PRODUCT CHANGE NOTICE

PCN#23-024

Mini-Circuits PN:	Replacement Models:	Replacement Guide:
PMA2-252LN+	PMA2-252LNA+	AN-60-112
PMA2-162LN+	PMA2-162LNA+	AN-60-111

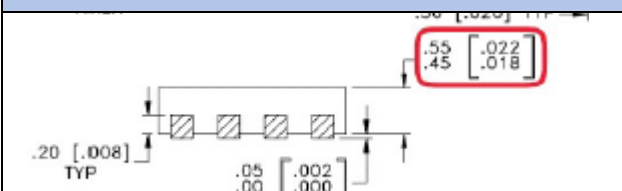
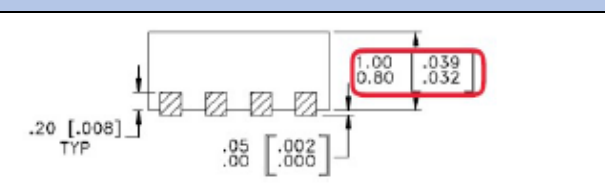
Change of package height

FROM:	TO:

- No change to **FUNCTION** (Performance)
- Change to **FIT** (Dimensions) and **FORM** (Appearance) per above

Change to package height based on available tooling
